**SERVICE BULLETIN**

INSPECTION OF KING KT76A TRANSPONDERS

# ***BENDIX/KING® Service Bulletin***

**BULLETIN NO:** SB KT 76A-7  
KT 76A ATC Transponder

Figure 1  
KT 76A Main Board  
300-05824-0040 Rev-8

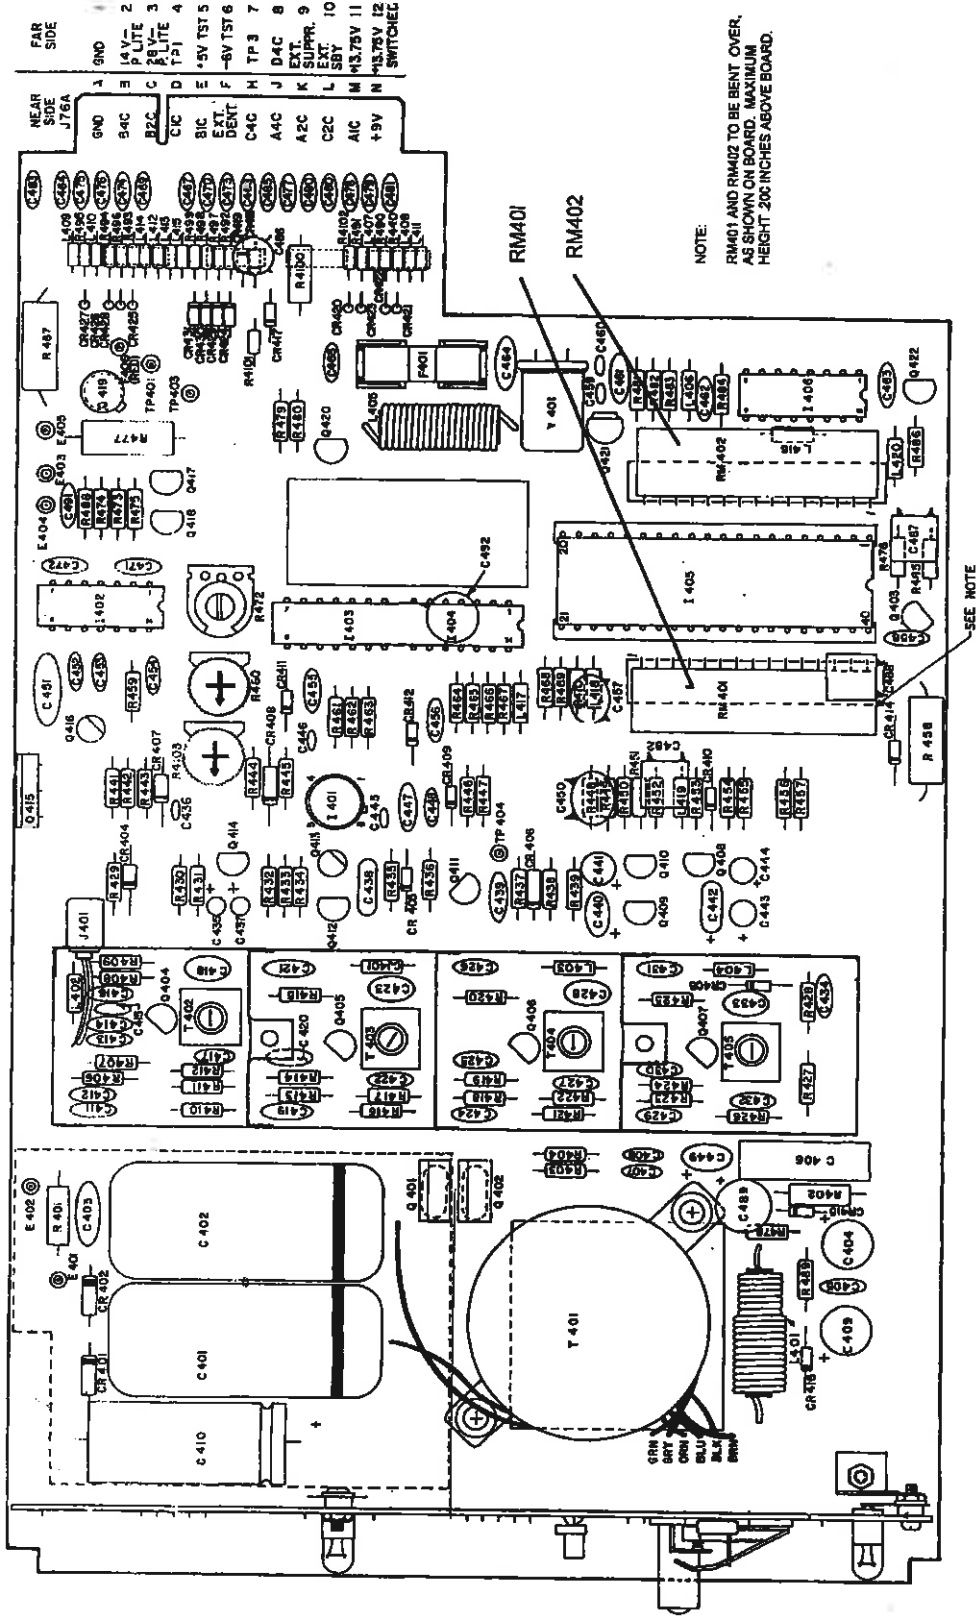
This modification consists of replacing two resistor network modules, RM401 and RM402, with new glass-coated parts.

1. Remove main board cover, and access the main board per the disassembly procedure contained in 5.3.4 of the maintenance manual.
2. Remove and discard old RM401 and RM402 from the main board.
3. Install new RM401 and RM402, P/N 015-00045-001, in the locations of the original parts.
4. Reassemble unit and reinstall covers.
